Item 3.**Development Application: 117 Victoria Street, Potts Point - D/2023/862**

File No.: D/2023/862

Summary

Proposal Summary: The application seeks consent for demolition of the existing residential building and structures and construction of a new part-four storey and part-eight storey residential flat building comprising 25 apartments, three levels of basement for car parking, servicing and storage and a rooftop communal open space with pool.

Figure 32: Excerpt from applicant's SEE showing height plane diagram of proposed building above the 15m height standard

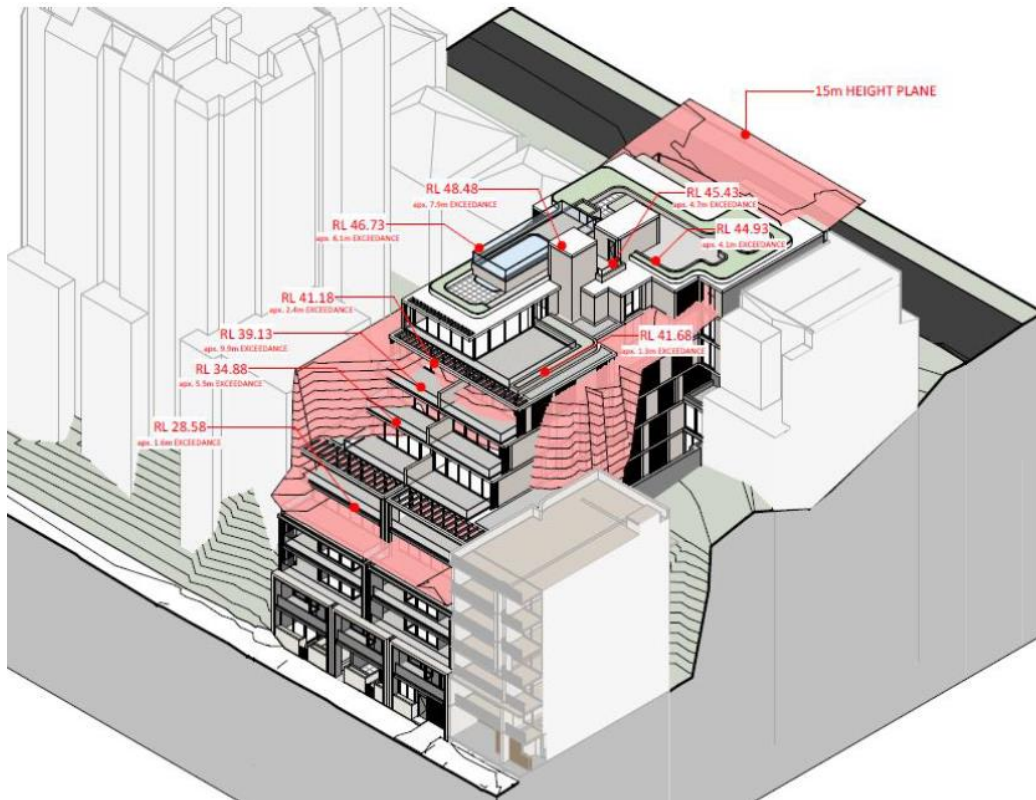
93. A height plane diagram submitted by the applicant showing the proposed exceedances above the 15m height control is shown below in Figure 32.

Figure 33: Excerpt of proposed southern elevation which shows building form which does not relate to the topography of the site (highlighted in yellow)

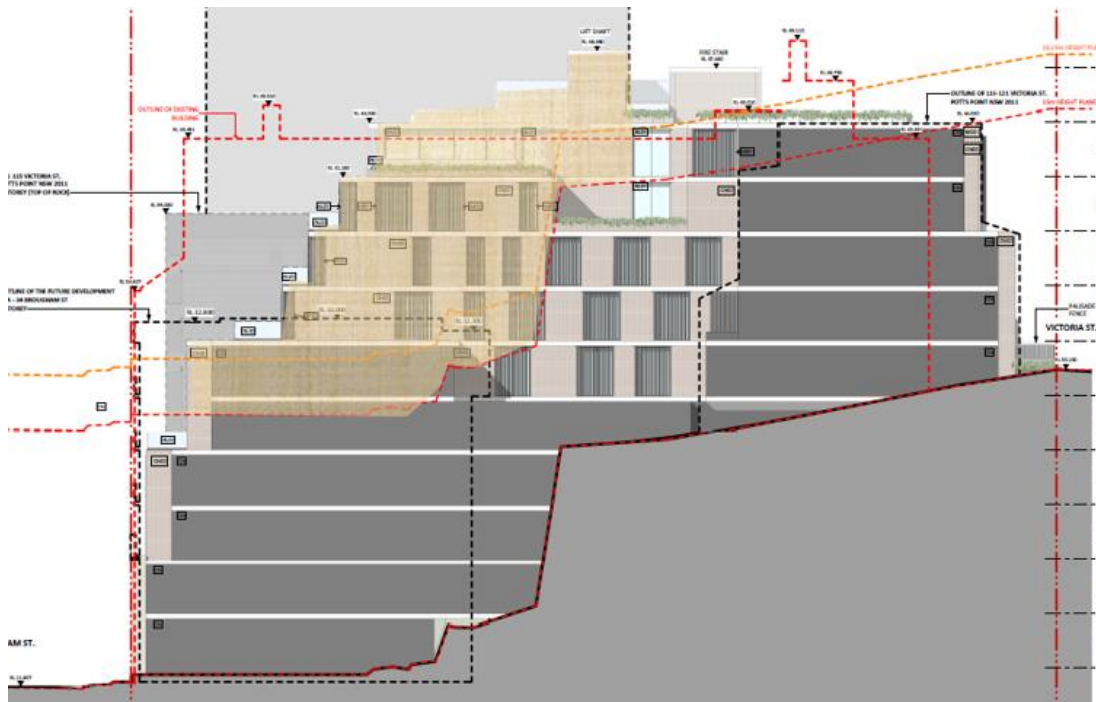
134. The proposed building does not relate to the stepped cross-sectional topography of the site (and the form of the height plane) and does not retain the taller portion of the building on the ridge as required by Section 2.4.3 of the Sydney DCP 2012. The unacceptable form is expressed in yellow in Figure 33 below.

Figure 34: Excerpt of proposed southern elevation which shows built to boundary sections of the proposed basement levels (highlighted in orange)

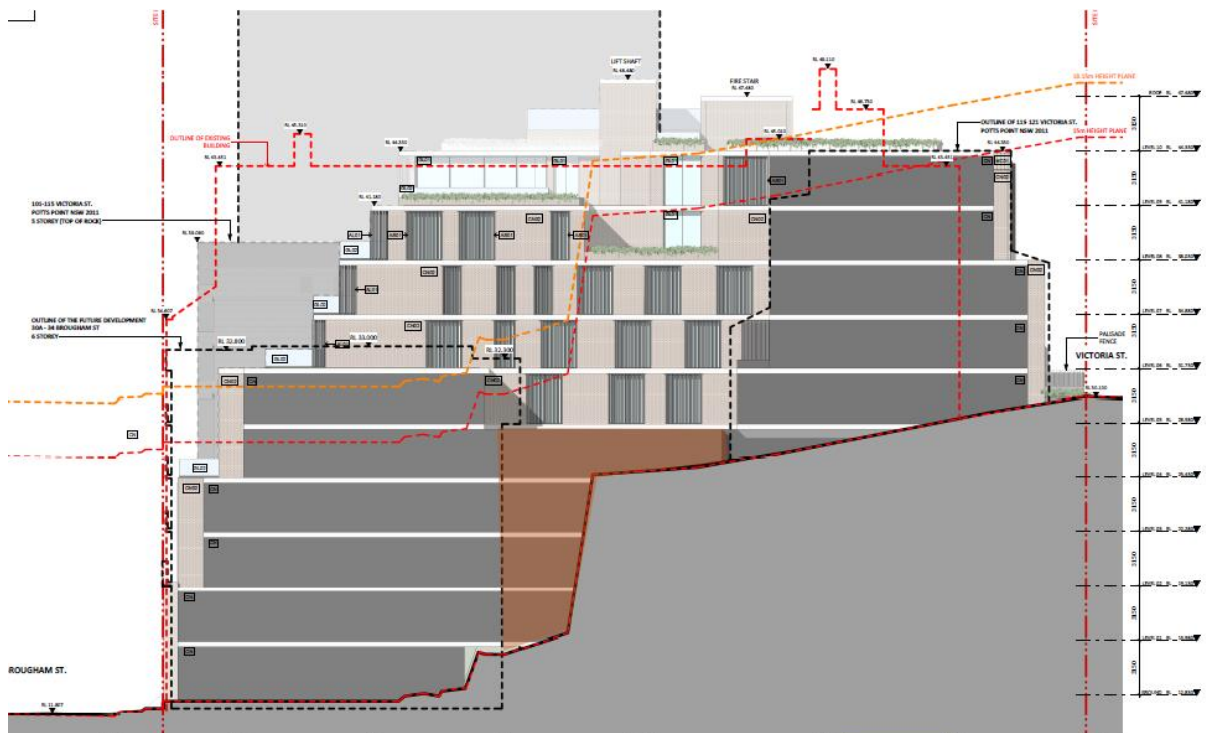
- 144. There is also insufficient detail relating to the impact of the proposed built to boundary basement walls, depicted in orange in Figure 34 below, on neighbouring properties.

- 145. These walls will have an overbearing impact on adjoining properties and do not comply with Objective 3J-4 of the ADG which states that protrusions of car parks should not exceed 1m above ground level.
